**PROJECT SCOPING PLAN FOR PERFORMING A CERCLA
REMEDIAL INVESTIGATION/FEASIBILITY STUDY (RI/FS) AT
BUILDING 804 AND THE ASSOCIATED RADIOACTIVE WASTE
BURIAL SITES (SEAD-12) AND THE MISCELLANEOUS
COMPONENTS BURIAL SITE (SEAD-63)**

**PROJECT SCOPING PLAN
REMEDIAL INVESTIGATION/FEASIBILITY STUDY
AT SEAD-12 & SEAD-63
SENECA ARMY DEPOT ACTIVITY
ROMULUS, NEW YORK**

**Parsons Engineering Science, Inc.
Prudential Center
Boston, Massachusetts**

**FIGURE 3-4
 SEAD-12A EM SURVEY
 QUADRATURE RESPONSE**

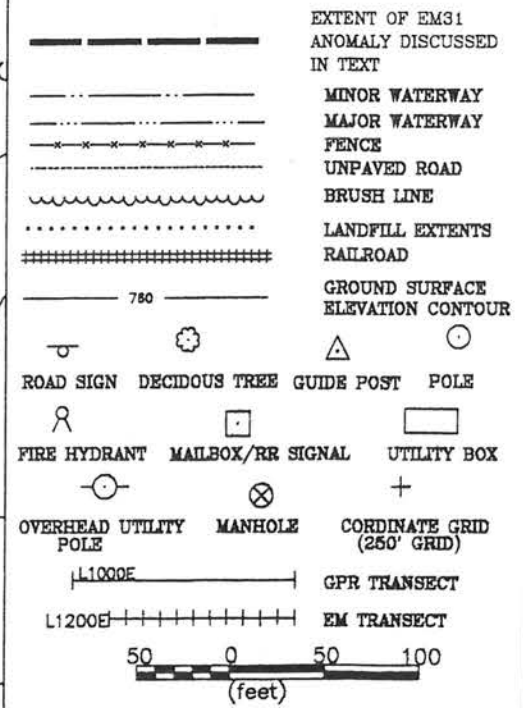
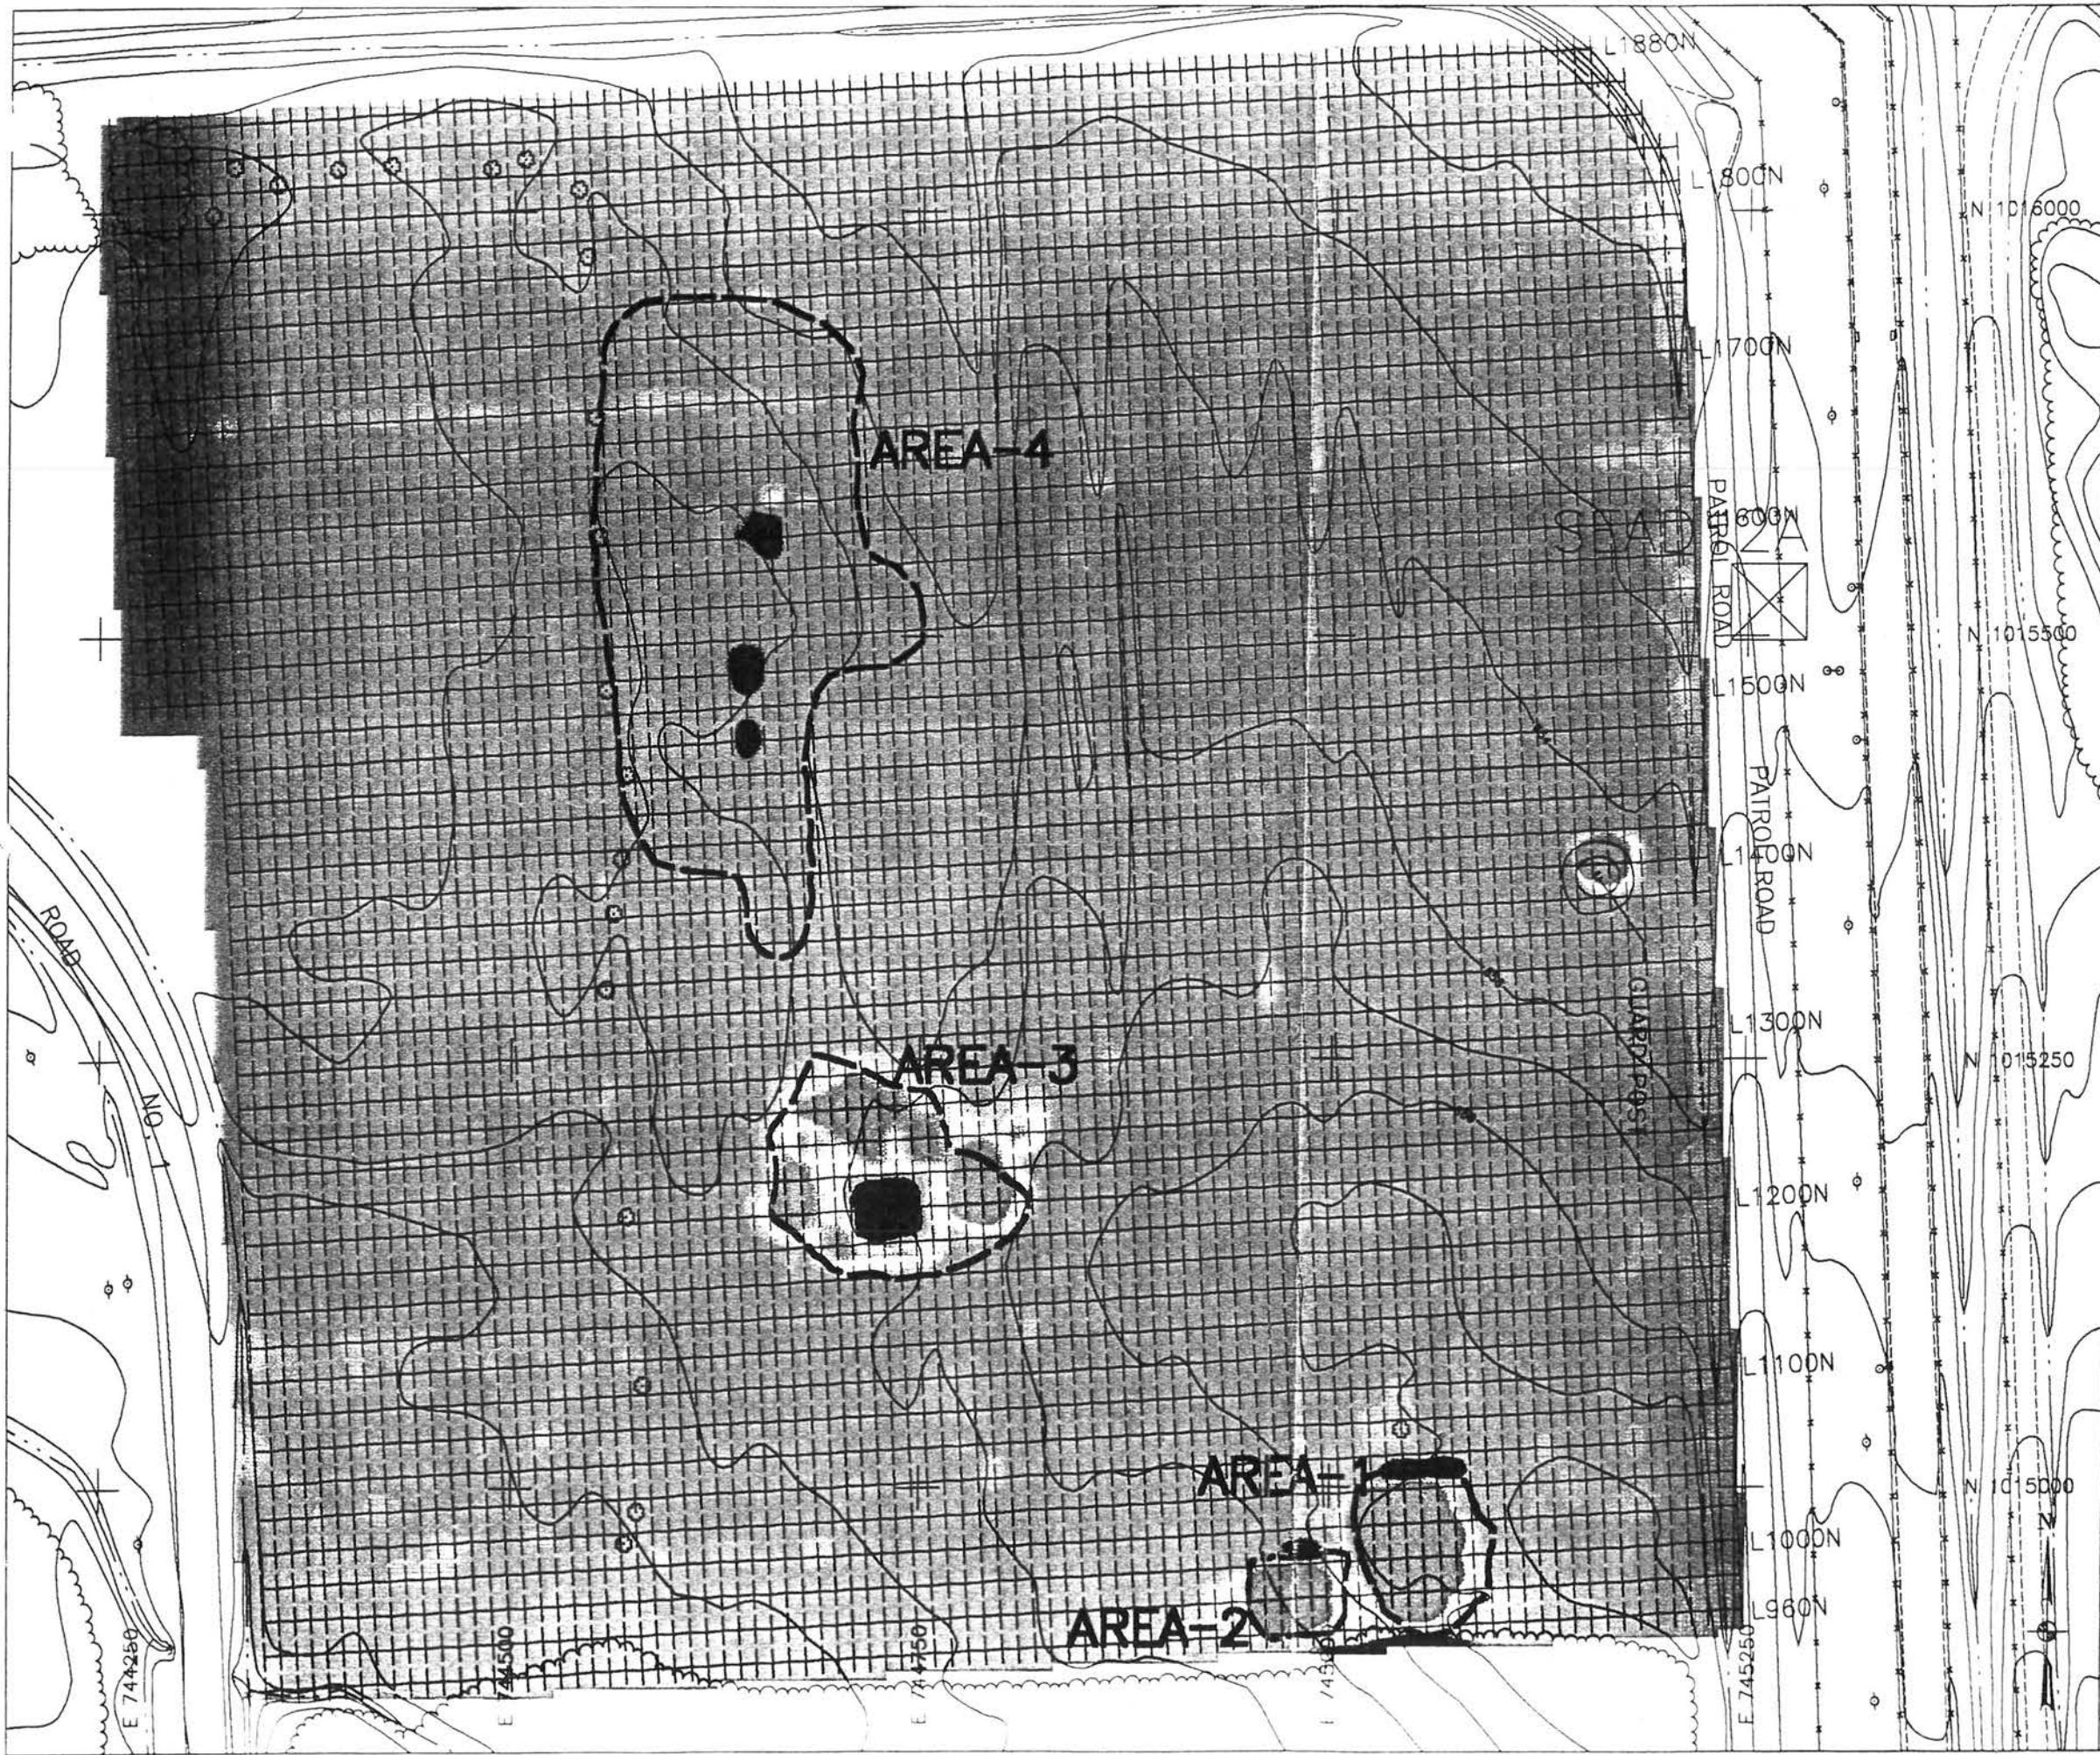
- Comment #3** **Page 3-8 EM Survey:**
The text gives the approximate dimensions of Area 1 as 65 feet long by 40 feet wide, Figure 3-4 shows this area as being approximately 90 feet long by 85 feet wide. Similar differences were also noted when comparing the text and figure for the remaining three areas. These discrepancies should be resolved.

FIGURE 3-8
LOCATION OF GPR SURVEYS
AND GPR ANOMALIES

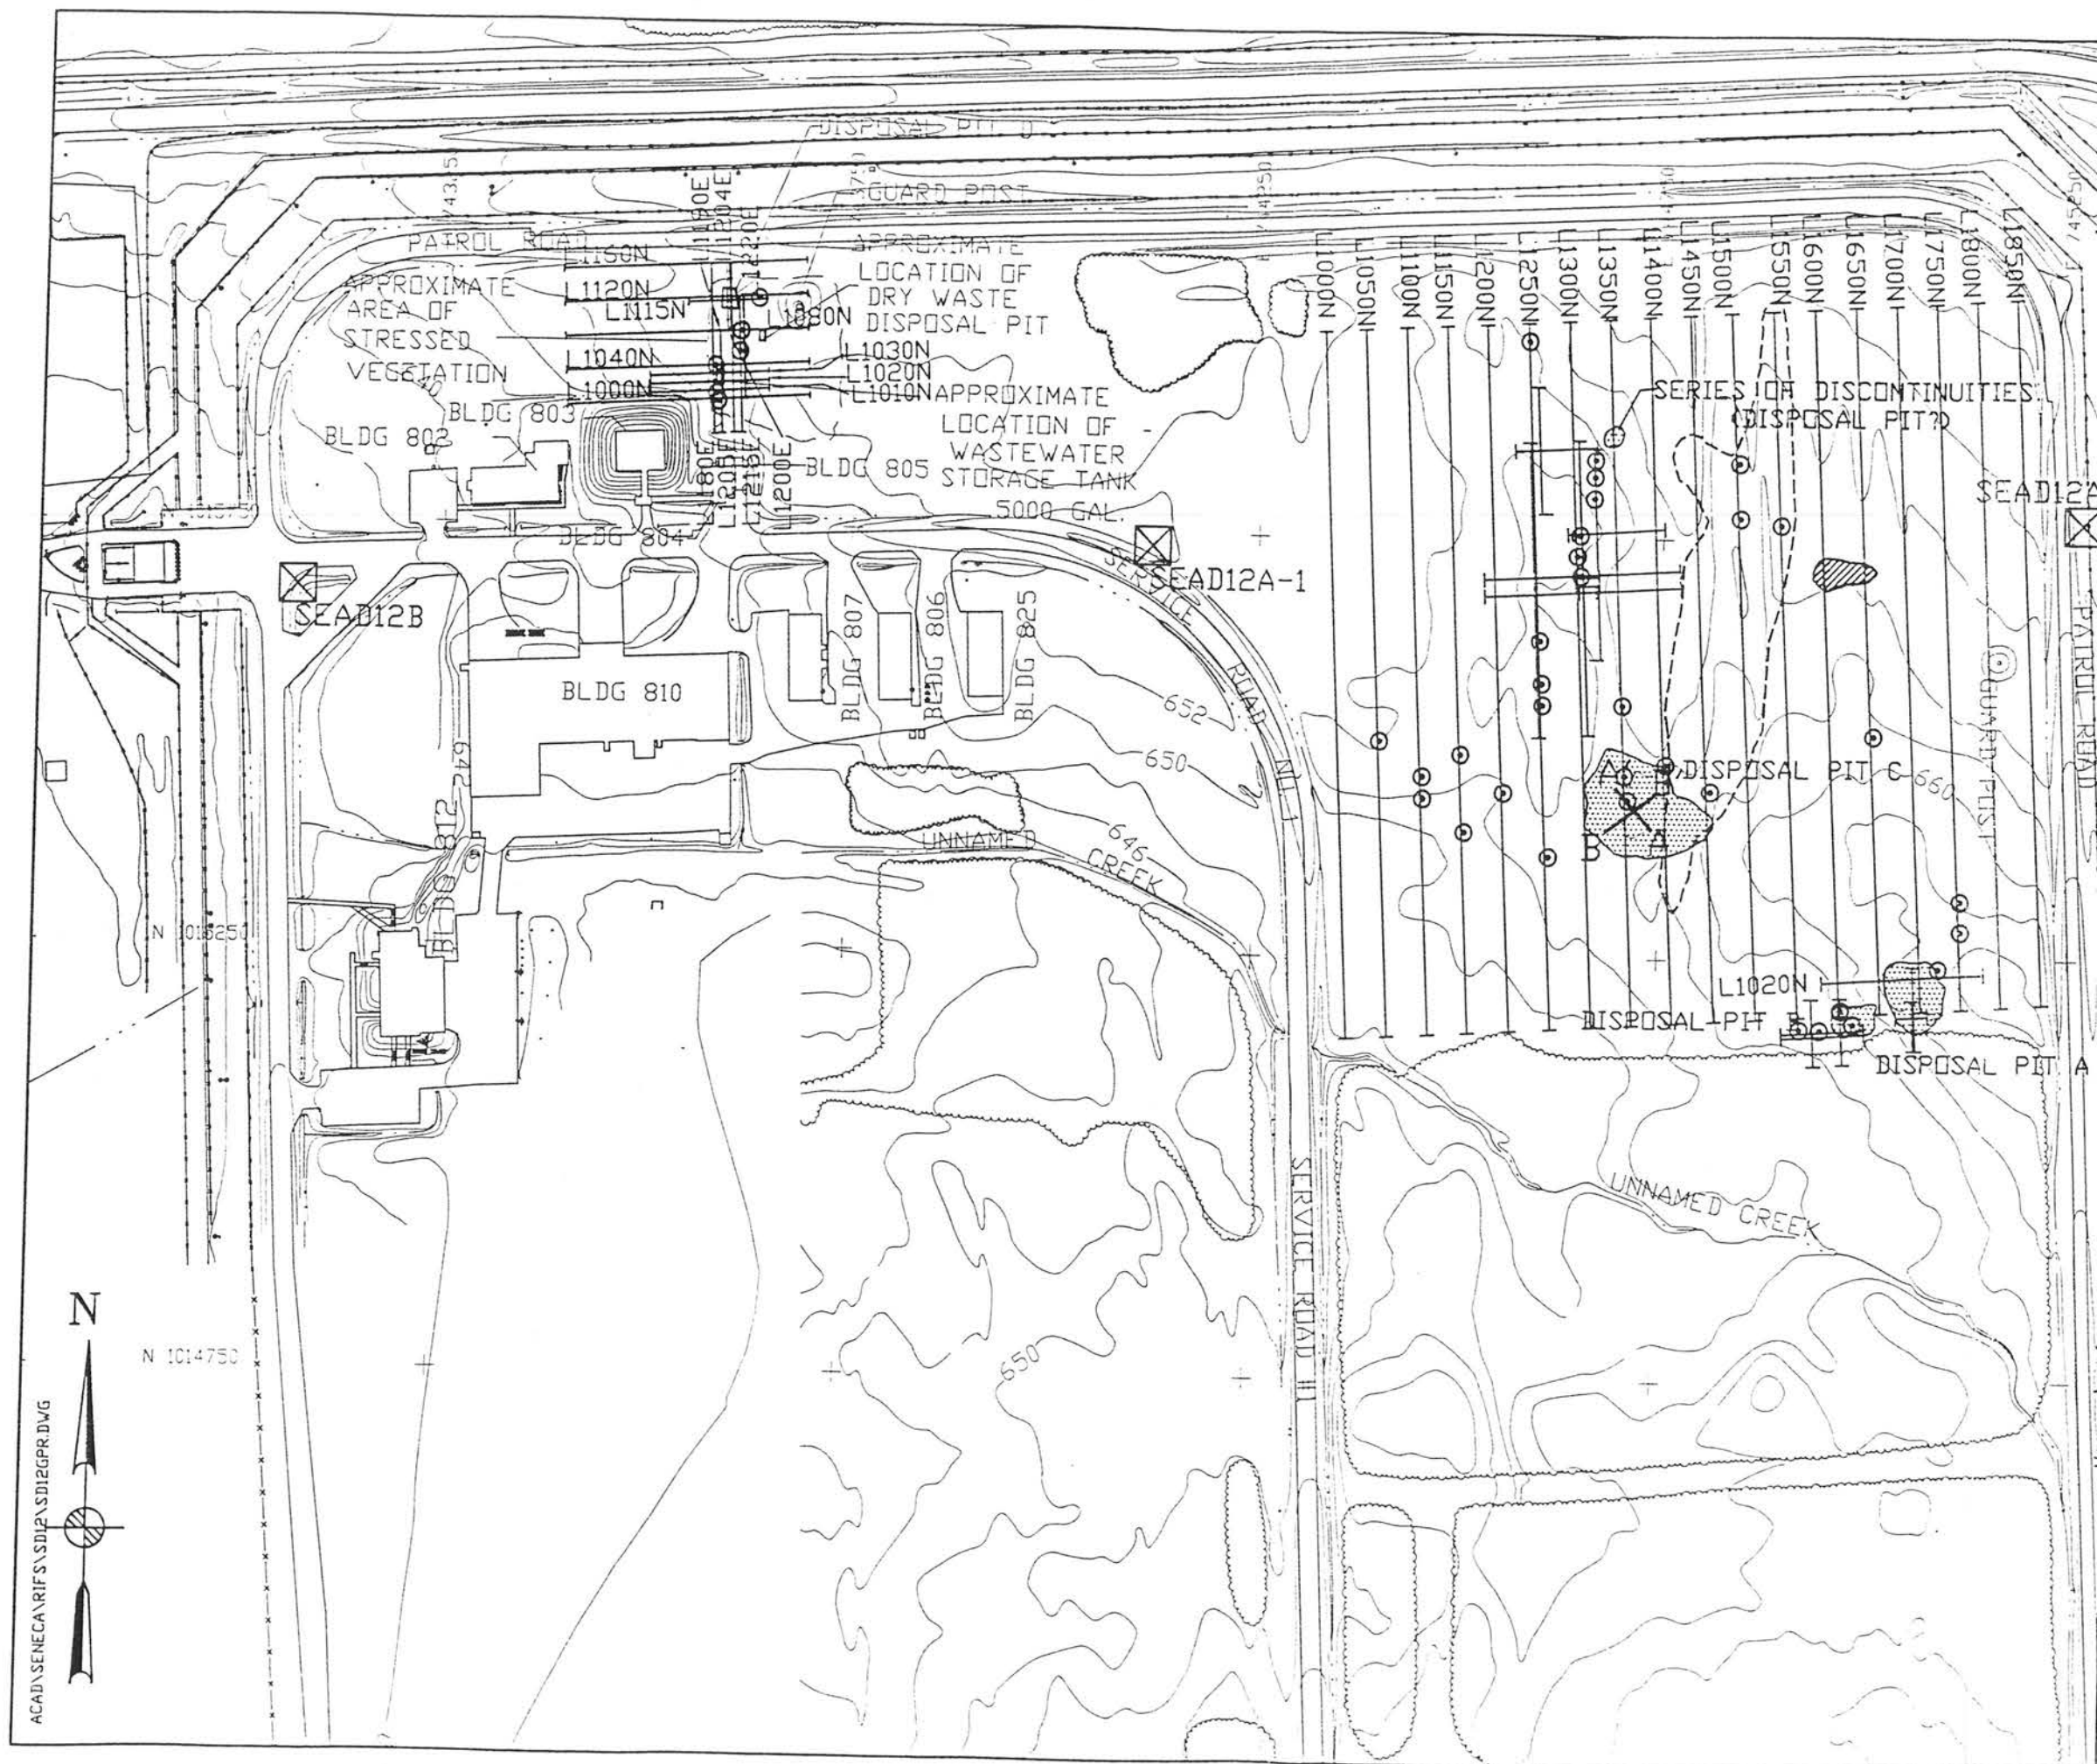
- Comment #4** **Page 3-20, p1:**
The measurements cited for the region of weak GPR signal are incorrect in the text based on a review of Figure 3-8.
- Response #4** Agreed. The region of weak GPR signal extends 600 feet north and is approximately 100 to 150 feet wide. The text has been revised.
